Cross River Rail Environmental Impact Statement

Request for Project Change 7
Design refinements and condition changes

Response to Pre-lodgement Information Request

Date: May 2020

Figure 1: Typical Sections – Enabling Works Near Lanham Street Compound

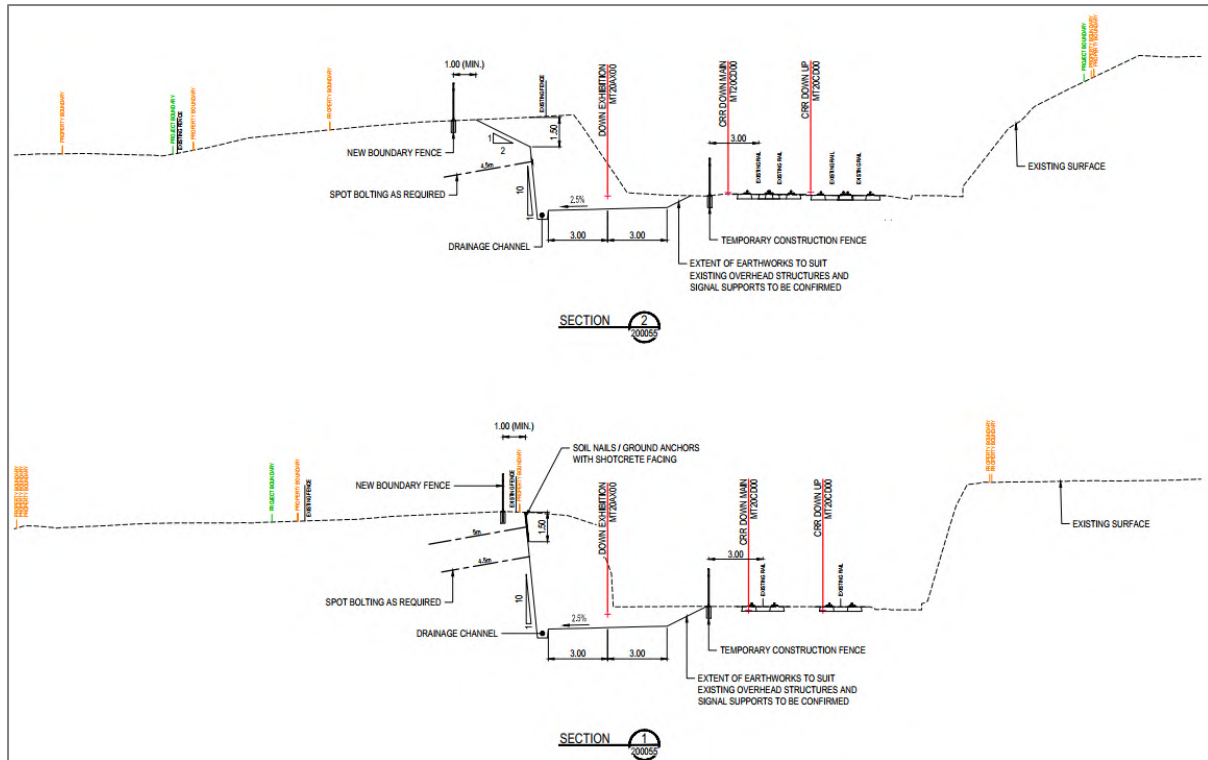
The scope of works for Lanham Street area is consistent with the works identified in RfPC-4. This includes widening of rail corridor to fit the third line. Further development of the preliminary design for these works and associated construction methodology to undertake the rock cutting have triggered a change in the land impact requirements in this area from a temporary construction requirements to permanent volumetric requirements. These works include installation of soil nails and rock bolts and are detailed in typical sections presented in Figure 1.

The railway corridor widening near Lanham Street remains consistent with the approved project footprint and impact. However, with further refined construction methodology developed to undertake the rock cutting works, this now triggers a land requirement changing from a temporary construction requirement to a permanent volumetric requirement.

Figure 2: Typical Soil Nail Wall Arrangement (North of Land Bridge)

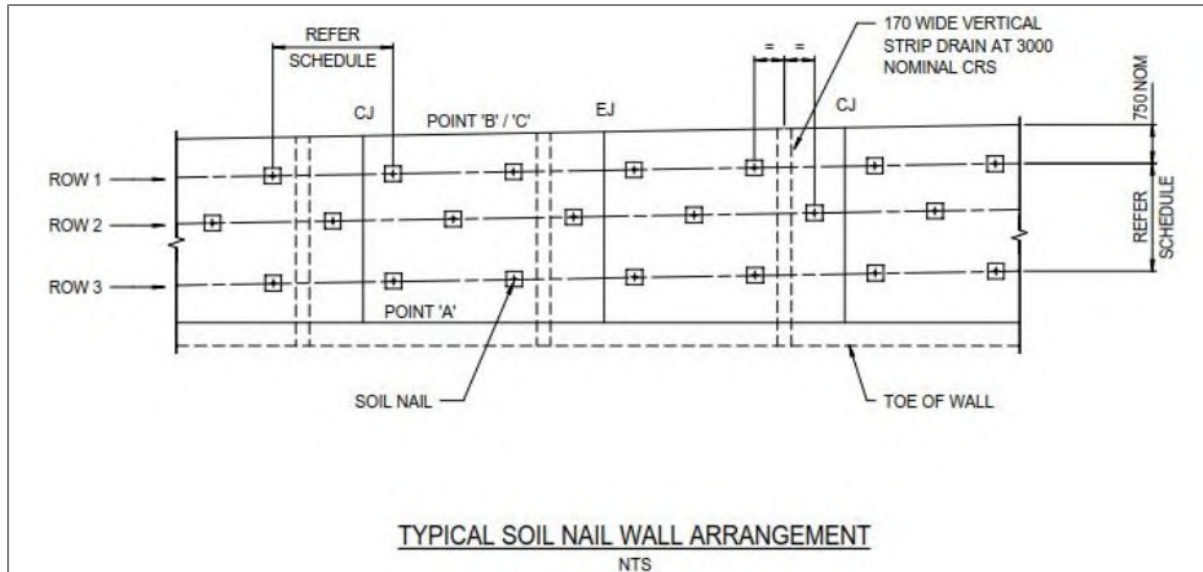
The retaining wall to the north of Land Bridge will be constructed along approximately a 200m long section of the corridor, commencing approximately 65m south of the BCC maintenance yard and extending south along the boundary to approximately 60m north of the Land Bridge. The height of the retaining wall will vary from 2.4m to 3.4m depending on the grade of the existing embankment. This retaining wall will be located wholly within the QR rail corridor, but in order to stabilise the slope, soil nails will be inserted in three rows, spaced every 1.50m to 1.75m along the length of the retaining wall (Figure 2 and Figure 3). These soil nails form underground anchors which are used to stabilise retaining wall which is a near vertical structure. With a subsurface intrusion of between 4m and 6m, these nails will extend into Victoria Park, and beneath some of the trees that line the boundary.

Figure 4: Soil Nail Typical Detail (South of Land Bridge)

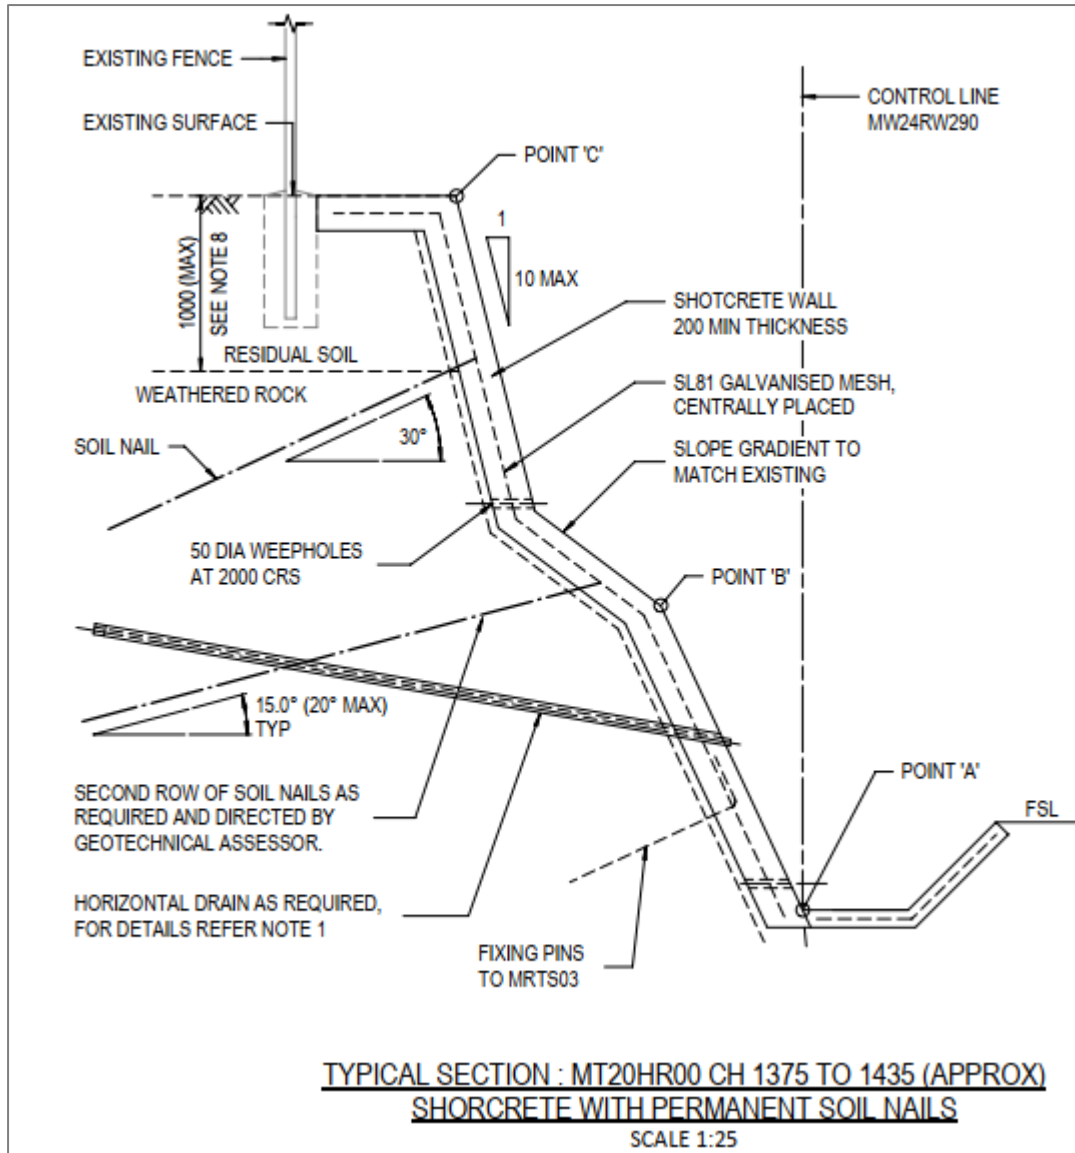
The retaining wall to the south of Land Bridge will be constructed along approximately a 240m long section of the corridor, starting near the tennis courts within the park and goes south towards the footbridge behind Brisbane Girls Grammar School. This retaining wall has two types of reinforcing elements - soil nails and fixing pins (Figure 4 and Figure 5 respectively).

Figure 6: Stormwater Bund - General Layout

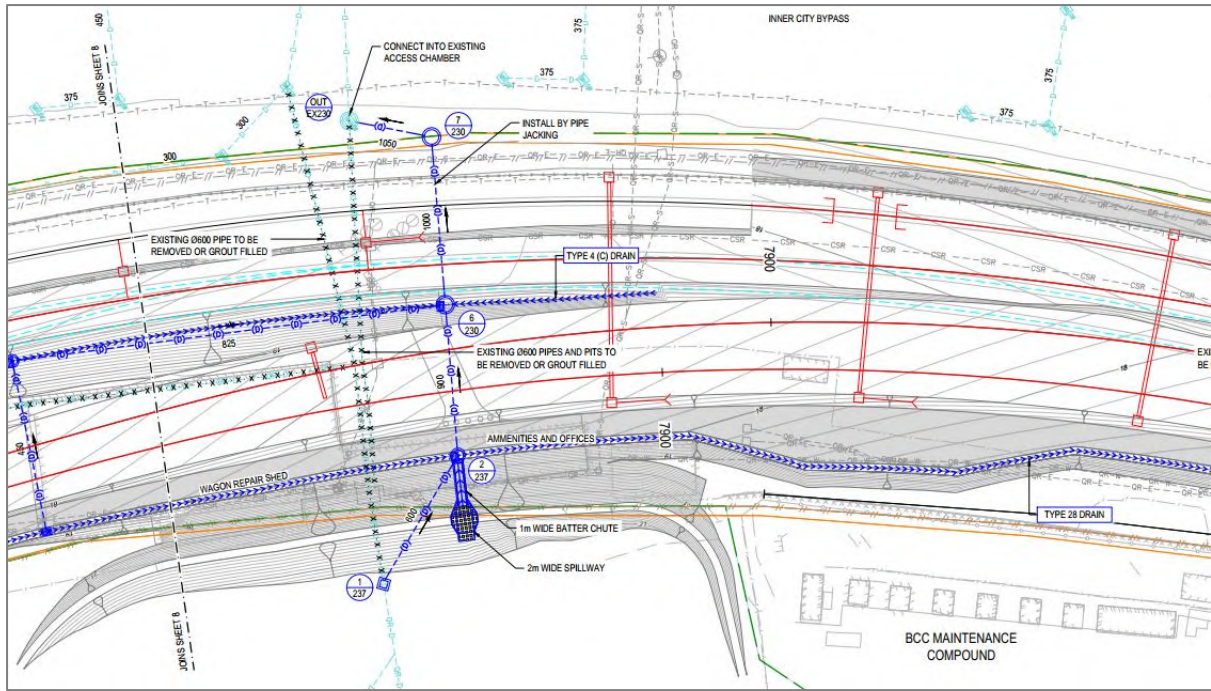
The proposed stormwater management works are required along the Normanby holding road and the QR fence line. This includes new drainage to provide appropriate surface water capture for the new infrastructure within the QR corridor. It also includes stormwater bund upstream of rail corridor boundary to capture run-off coming from the Victoria Park and connecting it to the existing stormwater drain in QR corridor through a spillway. These works will have a temporary construction impact on additional land to allow for constructability of stormwater bund. These works will be assessed and delivered under the Heritage Exemption Certificate approved by DES. Detailed layout of the stormwater bund and associated spillway is provided in Figure 6 and Figure 7.

Figure 8: Victoria Park Access – General Layout

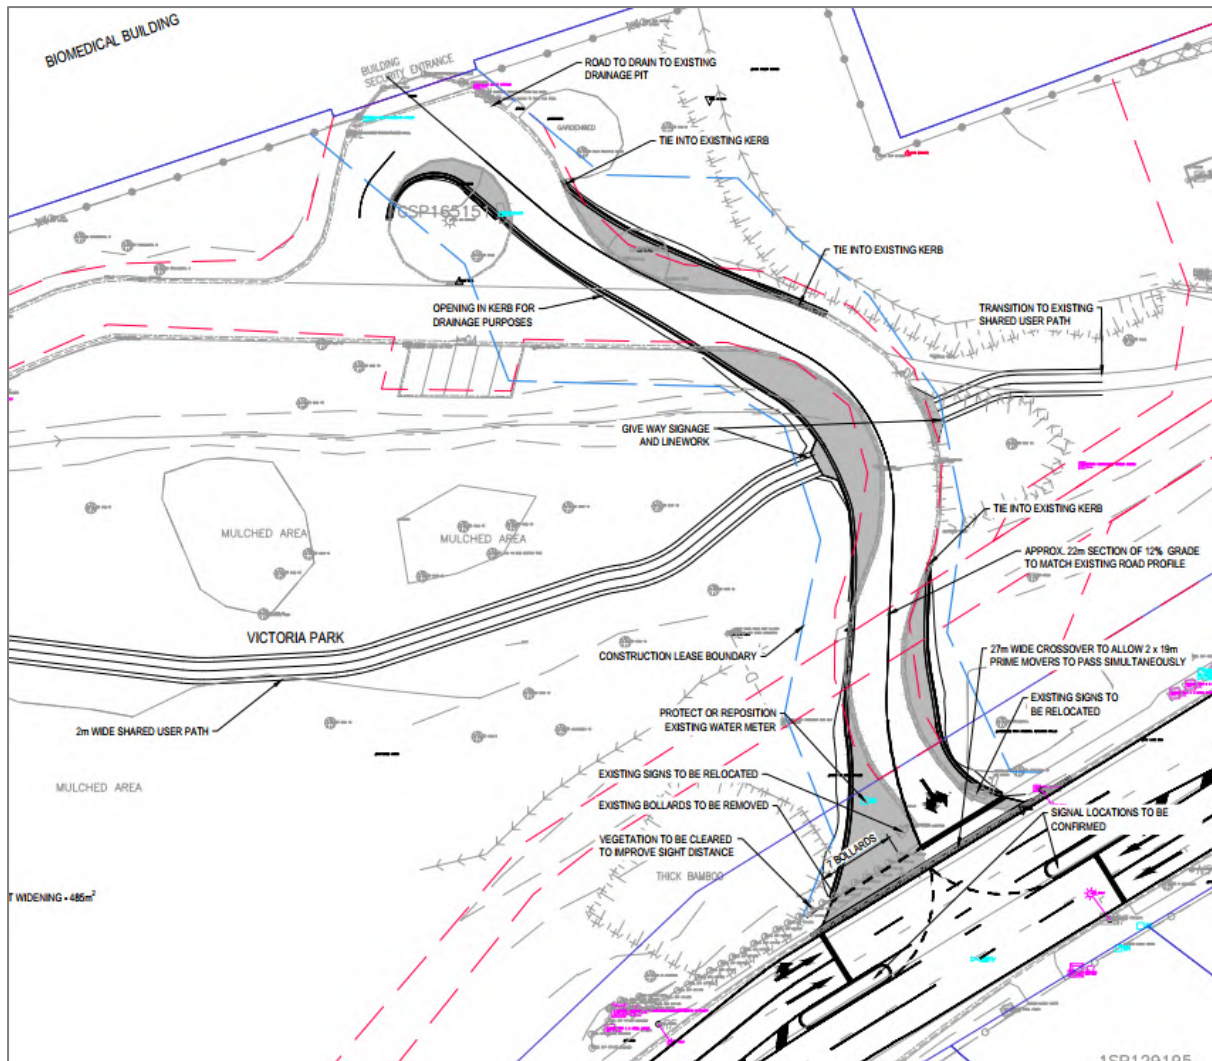
Victoria Park access entails the upgrade and operation of the existing access track including left in and left out driveway on Gregory Terrace and the construction and operation of a new Section of shared user path including an upgraded SUP crossing point. These works are consistent with the approved project. Detailed layout of the Victoria Park access is provided in Figure 8.
